TRANS/WP.29/GRSG/2001/1
12 January 2001

PROPOSAL FOR DRAFT AMENDMENTS TO REGULATION No. 52
(Small capacity passenger vehicles)

Transmitted by the Expert from Poland

Annex 3, Figure 1, amend as following:

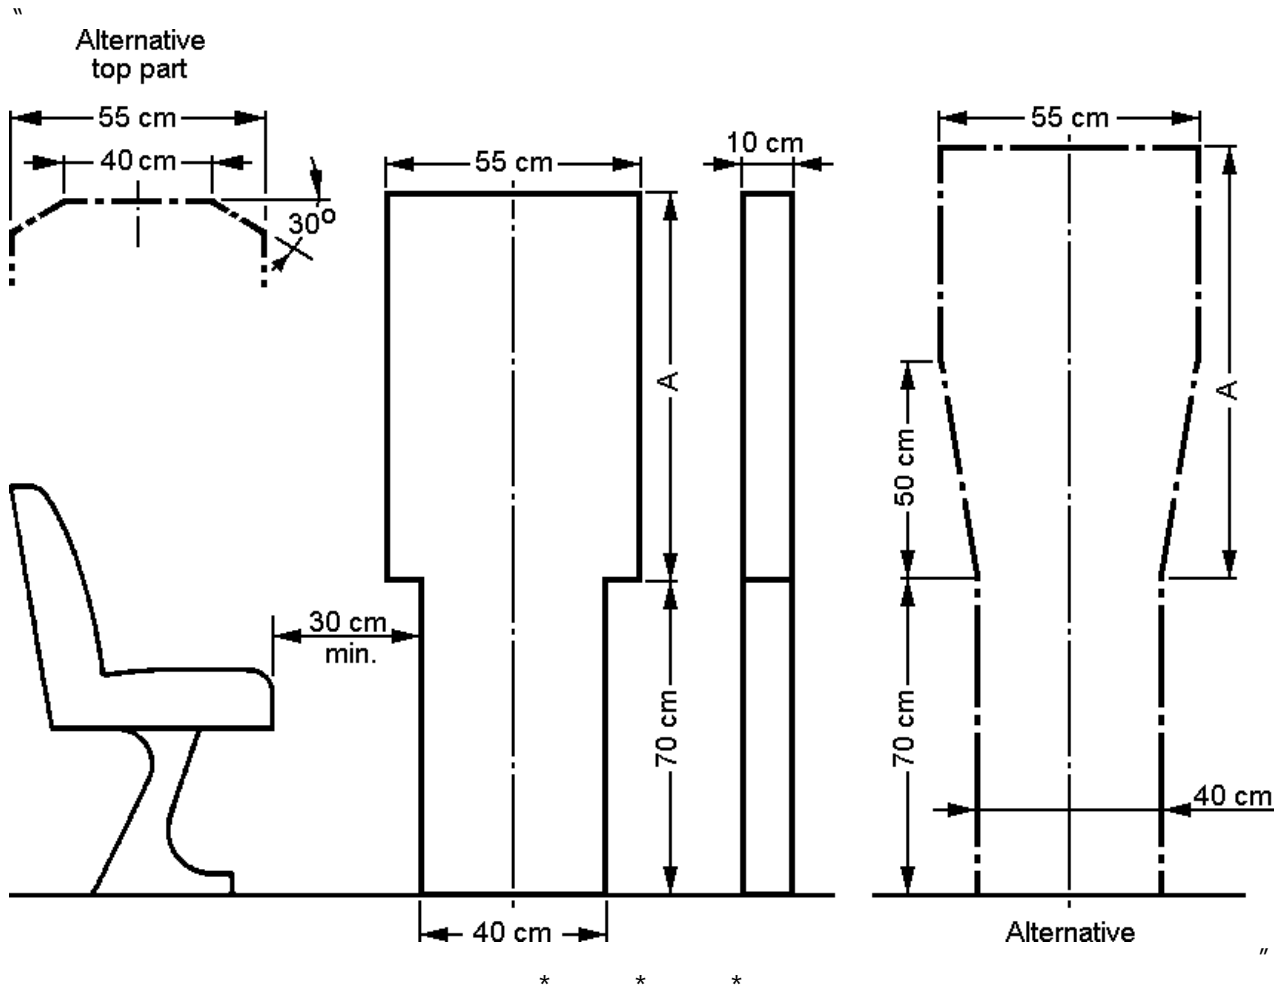
The "alternative top part" which is described in the third subparagraph of paragraph 5.7.1.1. was not shown in figure 1 of annex 3, as referred to.
